USE ON REVIEW REPORT

AGENDA ITEM #: ► FILE #: 8-A-21-UR 22

APPLICANT: WALKER SPRING VILLAS, THE CHEF'S WORKSHOP

PROPOSED USE: Multi-dwelling development with detached houses

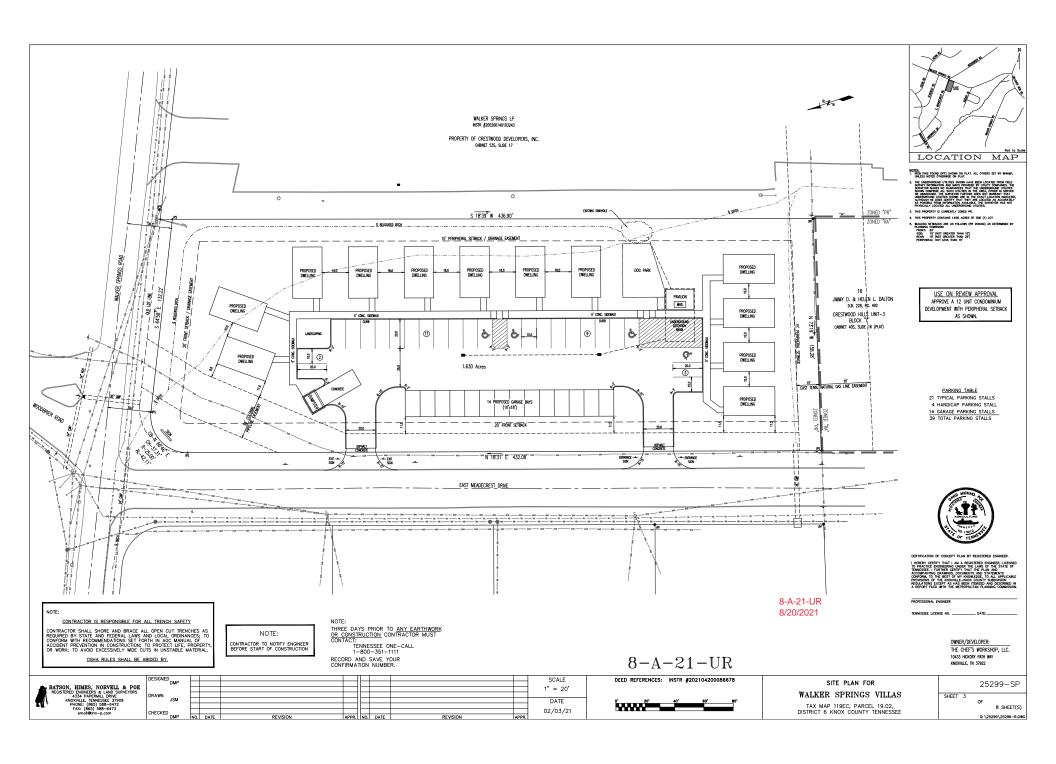
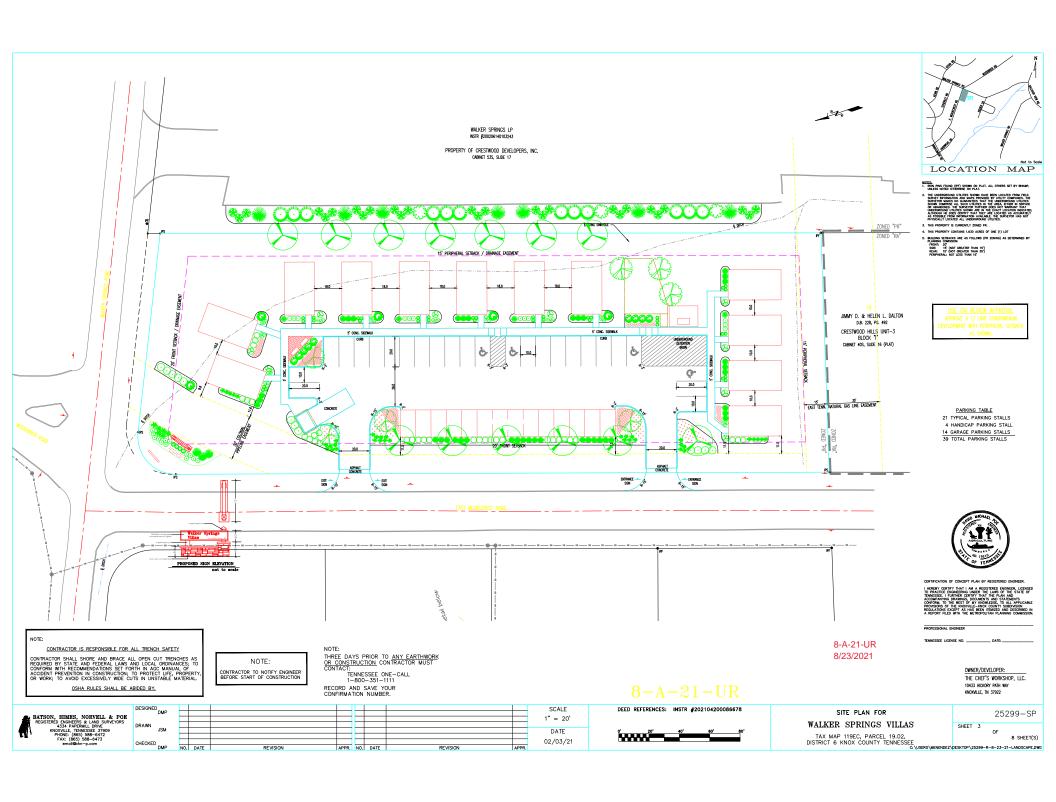
- 1. <u>Walker Springs Road frontage (north lot line)</u>: Applicant (20-ft setback) -- Staff (35-ft setback). The applicant's plan shows 8-ft of right-of-way dedication along this frontage which matches what would be required by the Major Road Plan if this property were being subdivided into two or more lots. Since this property will remain one lot, right-of-way dedication is not required. The closest structure to the proposed lot line is setback 32-ft. If additional right-of-way is not dedicated, the structure will be 40-ft from the Walker Springs Road right-of-way.

- 2. <u>E. Meadecrest Drive frontage (west lot line)</u>: Applicant (20-ft setback) -- Staff (25-ft setback). The closest house on the plan is located 24-ft from the front property line and the established setbacks for the houses on the same side of this block range from 35-ft to 50-ft, with the adjacent house being setback 42-ft. Having a setback that more closely matches the houses on this block would make obtaining the proposed/allowed density difficult without changing the type of dwellings proposed, such as attached houses.

- 3. <u>South lot line</u>: Applicant (15-ft) -- Staff (25-ft). The proposed peripheral setback aligns with the East Tennessee Natural Gas Line easement on this property. The closest proposed house has a setback of 29-ft so the recommended peripheral setback of 25-ft will not impact the current layout and will ensure the space between the new house and the south lot line will be similar to the proposed site plan if the building locations are adjusted some during permitting.

- 4. <u>East lot line</u>: Applicant (15-ft) -- Staff (15-ft). The requested setback will not significantly impact the adjacent apartment complex which has a parking lot along this property line. However, the drainage easement along this lot line may need to be up to 20-ft wide to accommodate the stormwater through this site, which could impact the location of the houses. The easement width will be determined during permitting when a detailed stormwater plan is developed. A portion of this drainage easement could also be located on the adjacent property if the adjacent property owner is agreeable.

There are two potential sinkholes on this site; one is located in the northeast quadrant of the site near the eastern house that backs up to Walker Springs Road and the other is just east of the proposed dog park. The

There is a significant amount of stormwater that passes through this site, entering from two culverts in the northwest corner of the property and running through a ditch to the southeast corner of the property. The applicant proposes to relocate the ditch so it runs along the north and east property lines and then exits the site in the same location as it does currently. Because of the large volume of stormwater that passes through the site, the required drainage easement may be larger than usual (approximately 20-ft). This could impact the location of the houses that back up to the east lot line. The required stormwater detention for this site is proposed as an underground detention basin that is under the southeast corner of the parking lot and the mail pavilion.

▶ Approve the multi-dwelling development with up to 12 detached dwelling units and the reduction of the peripheral setback from 35-ft to 25-ft for the E. Meadcrest Drive frontage (west lot line) and the south lot line, and reduction to 15-ft along the east lot line, subject to 8 conditions.
